REPLACEMENT OF HEATING LINES

HEATING & VENTILATING PLA

BAKERSFIELD CITY SCHOOL DISTRT.
BAKERSFIELD CALIFORNIA
BOARD OF EDUCATION

C-335
JOB No. 57-23

PLAN UNIT "C" HEATING
Scale 1/8" = 1'-0"

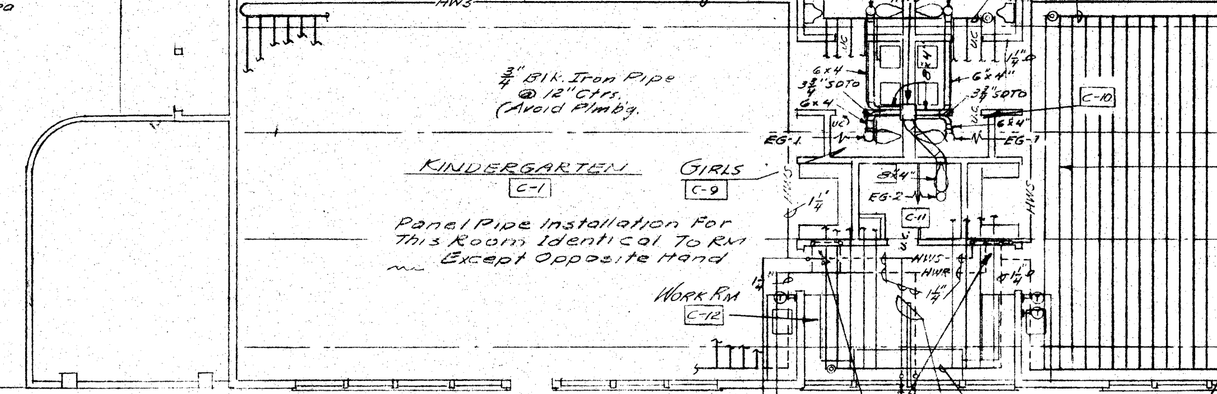
REPLACE LINES TO 2' BEYOND EDGE OF SIDEWALK

Replaced Summer 83 PVCP unit "D" to Ventilators

REPLACE

REPLACE LINES TO THIS POINT
